REVIEW CHECKLIST FOR EXISTING CONDITION OF CURB RAMPS ADA COMPLIANCE

PROJECT ID: **6020-04-02/72**

INTERSECTION: HWY: **US 51** SIDEROAD: **Tomlinson Road**

County Q/CS / North Street Intersection, Poynette WI

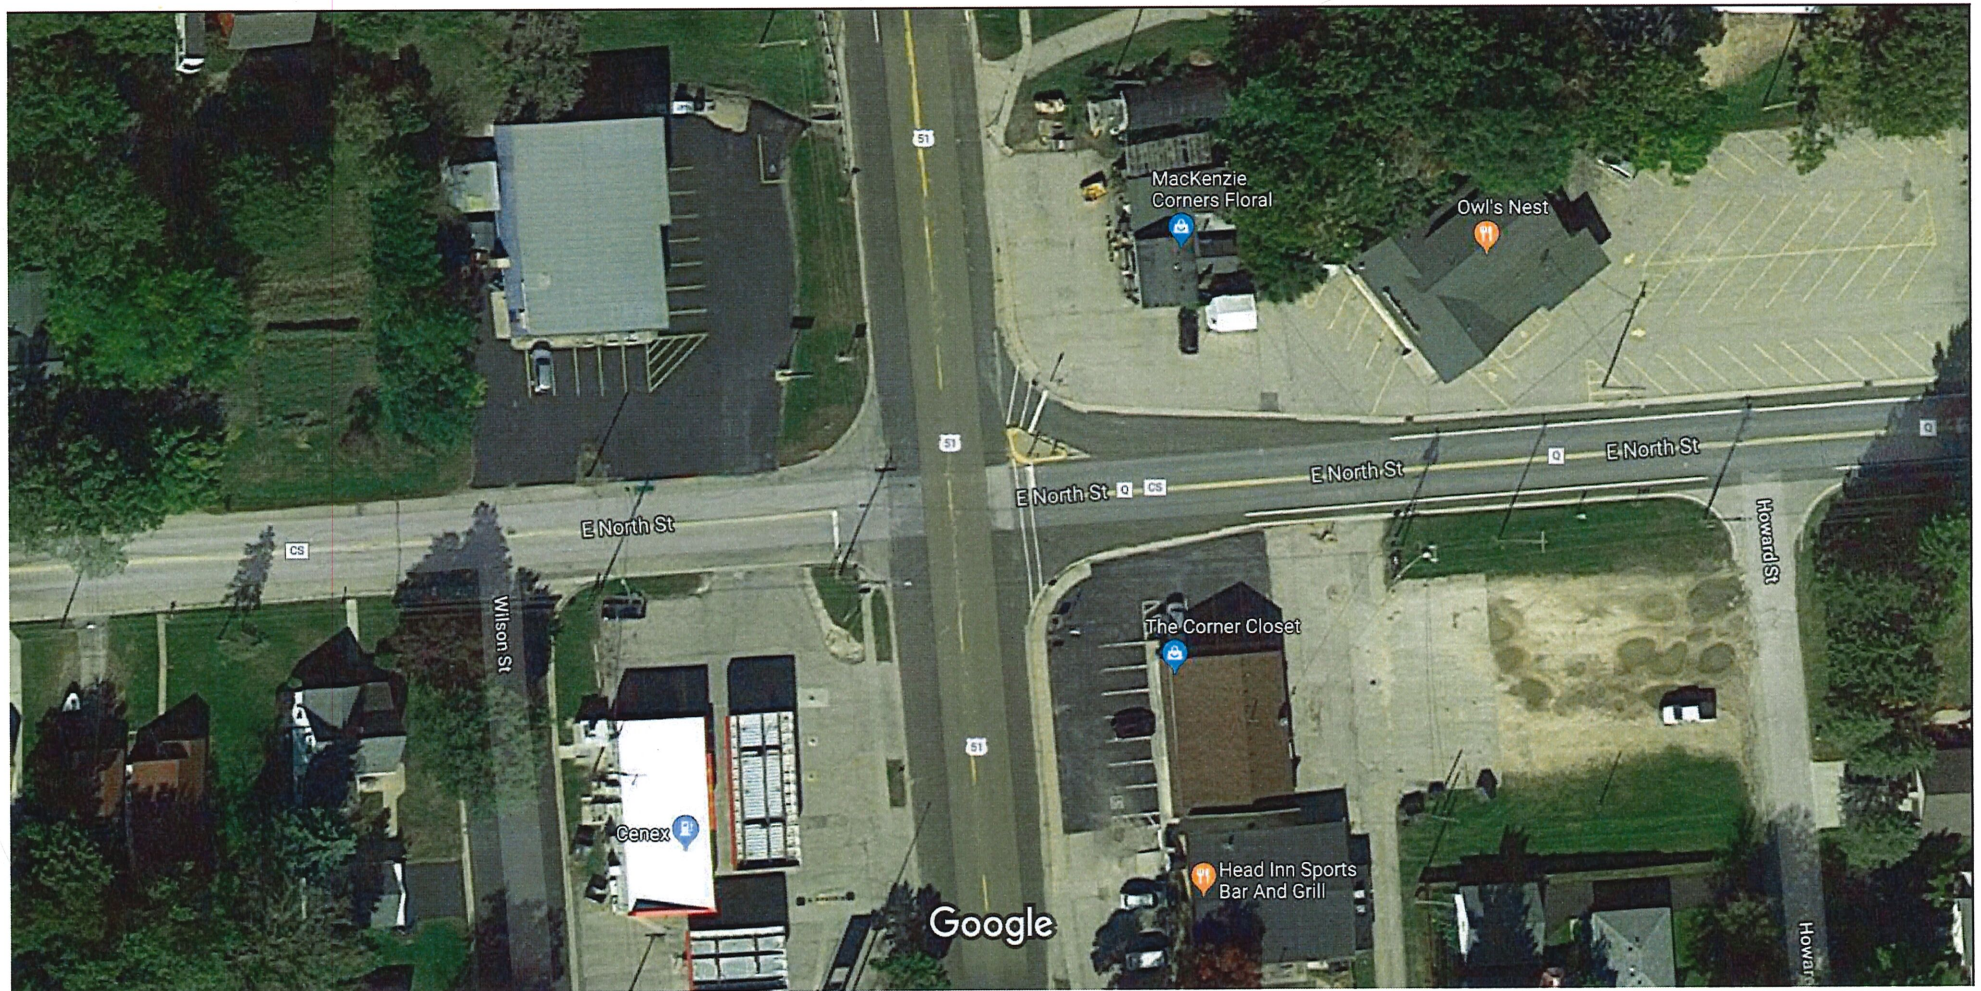
Update all curb ramps as indicated on other side. Consider adding curb ramps in NW quad to True Value if new business goes in after True Value closes. Add curb ramp to north side of driveway curb return at MacKenzie Corners Floral.

NW QUADRANT (True Value)				NE QUADRANT (MacKenzieCorners Floral/Owl's Nestl)			
RAMP	A	B		RAMP	A	B	
TYPE	NONE	NONE		TYPE	NONE	Type 6 (channelizing island)	
LONG. SLOPE	%	%		LONG. SLOPE	%	14.5 %	
CROSS SLOPE	%	%		CROSS SLOPE	%	2.4 %	
FLARE SLOPE	%	%		FLARE SLOPE	%	%	
DWF	select one	select one		DWF	select one	None	
RAMP CONTROL	select one	select one		RAMP CONTROL	select one	None	
CONDITION	select one	select one		CONDITION	select one	Weeds	
LANDING AREA	' " x ' "	' " x ' "		LANDING AREA	' None" x ' "	' " x ' "	
SLOPES	% x %	% x %		SLOPES	% x %	% x %	
TERRACE	' "	' "		TERRACE	0' 0"	0' 0"	
EXT. LONG. SLOPE	%	%		EXT. LONG. SLOPE	%	%	
EXT. CROSS SLOPE	%	%		EXT. CROSS SLOPE	%	%	
PORK CHOP	NO	NO		PORK CHOP	NO	YES (see additional sheet)	
COMMENTS:	No curb ramps, consider adding? True Value closing, but maybe new business will open there			COMMENTS:	Replace Type 6 ramps - no additional sheet. No DWF or ramps in pork chop but marked crosswalk. Add level landings, add type 4 curb ramp at N edge of driveway to MacKenzie Corners Floral.

EXT. LONG. SLOPE	%	%		EXT. LONG. SLOPE	%	%	
EXT. CROSS SLOPE	%	%		EXT. CROSS SLOPE	%	%	
PORK CHOP	NO	NO		PORK CHOP	NO	NO	
COMMENTS:	Replace with Type 2 ramps if adding ramps in NW quadrant, else construct half of Type 2 to provide E-W ramp			COMMENTS:	Inlet behind sidewalk. Replace Type 3 ramps and add level landings. These ramps may need to be parallel ramps depending on R/W.
